HISTORIC PRESERVATION BOARD STAFF REPORT

516 N. Swinton Avenue

Meeting	File No.	Application Type
August 5, 2026	HP-526-2026	Certificate of Appropriateness, Demolition, Variance, & Waiver

The item before the Board for consideration of a Certificate of Appropriateness (HP-526-2026), Demolition, Variance and Waiver requests for a second-floor addition to an existing non-contributing one-story garage structure for use as a guest cottage for the property located at **516 N. Swinton Avenue (Harden-Hart House), Individually Designated to the Local Register.**

EXISTING + PROPOSED
NORTH ELEVATION PROFILE

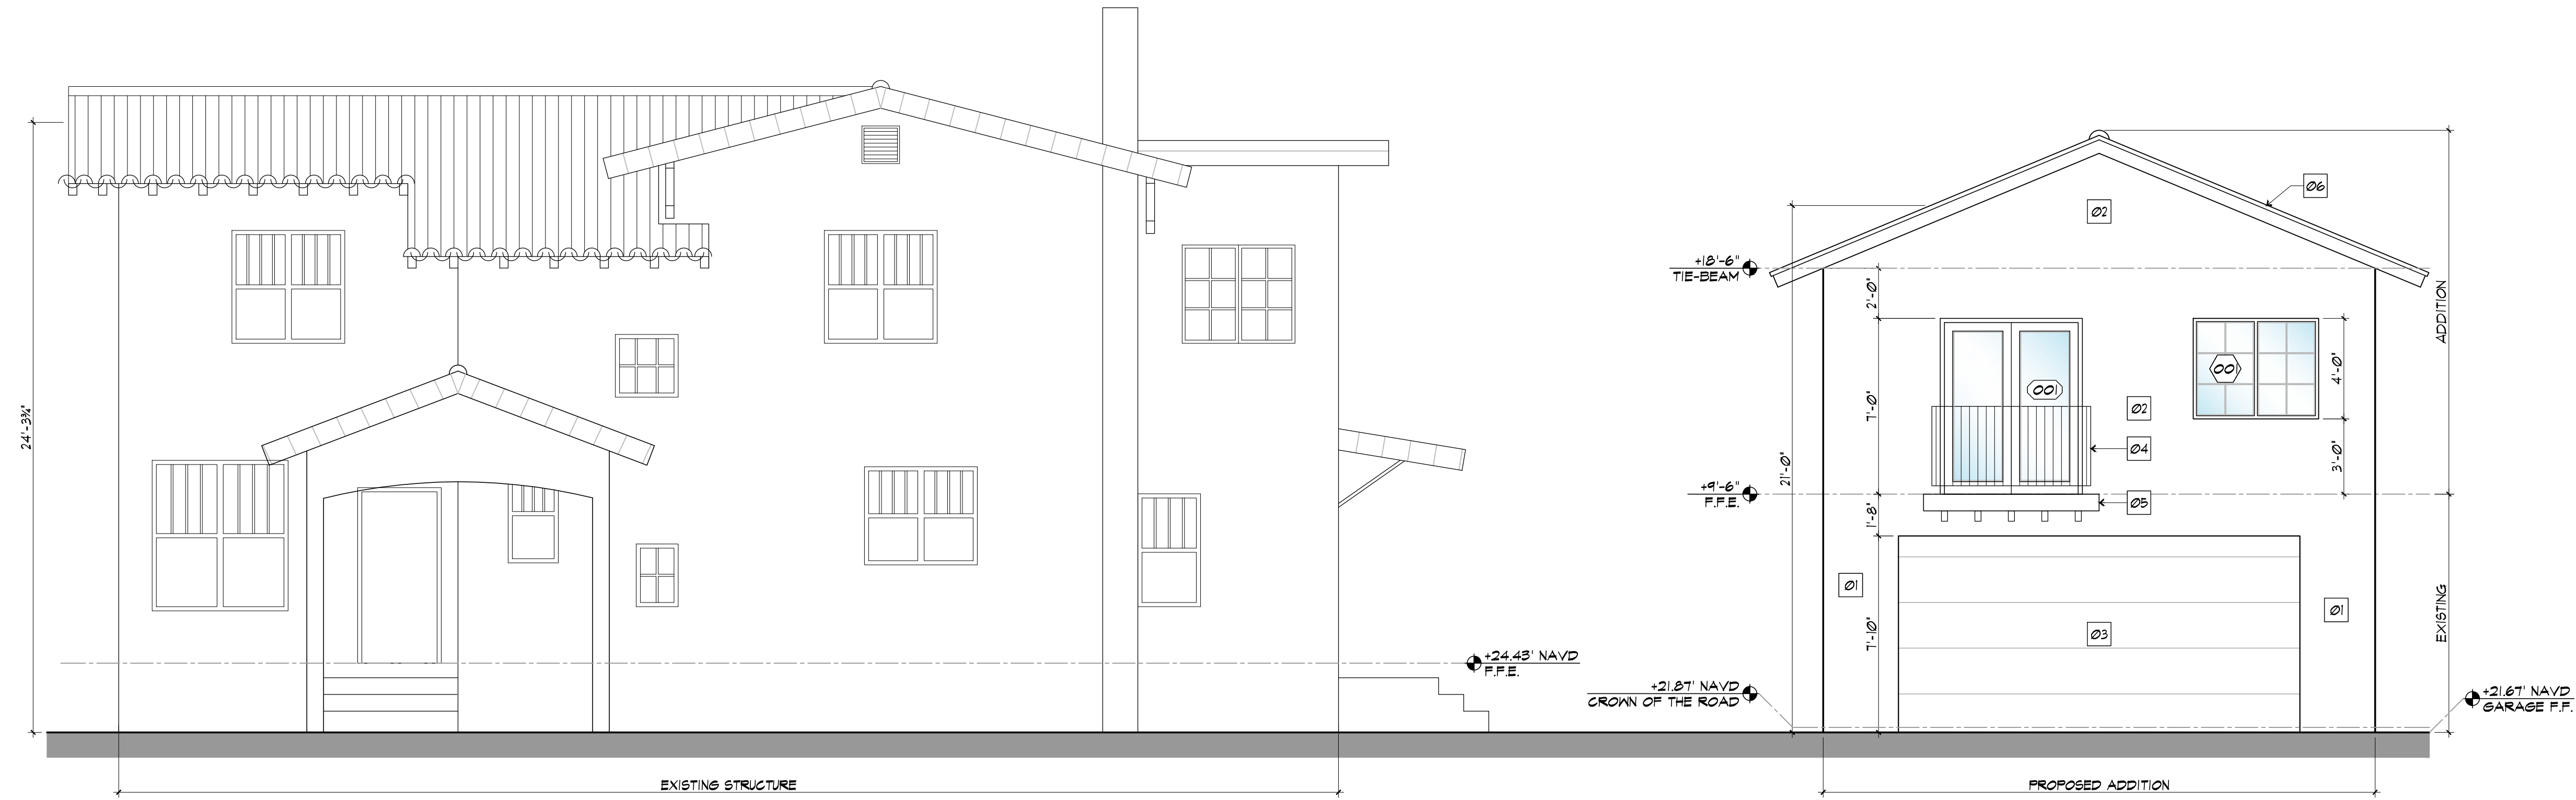
The proposed second story addition to the existing garage will increase in height from an existing 9 feet 6 inches to 21 feet. It will not exceed the height of the existing principal structure, which is 24 feet 3¼ inches. The floor area of the accessory structure is also proposed below the maximum 40% of the floor area of the principal structure. As the accessory structure is proposed to be larger than 350 square feet, the design standards are applicable. The proposed architectural style is to retain the Mediterranean Revival style that the principal structure and existing garage utilize including a textured stucco finish and barrel tile roofing. The accessory structure is located directly behind the existing principal structure, making it somewhat visible from the adjacent North Swinton Avenue public right-of-way, however, there are visual compatibility standards that are applicable to the structures façade, discussed later in the report.

With respect to Height, the Land Development Regulations indicate that accessory structures are not permitted to be taller than the principal structure. The proposal meets the requirements, as it is shorter than the principal structure by 3 feet 3¼ inches. There will be a height change for the rear accessory structure changing from an existing one-story structure at 9 feet 6 inches to 21 feet for the second story addition. The proposed roof profile will retain the same appearance as exists on the accessory garage structure, which is currently compatible with the principal structure. The proposed materials and colors can also be seen as appropriate as the textured siding, barrel tile roofing, black aluminum balcony railing, and white window frame/glass colors are elements either currently seen on the principal structure or compatible with the Mediterranean Revival architectural style.
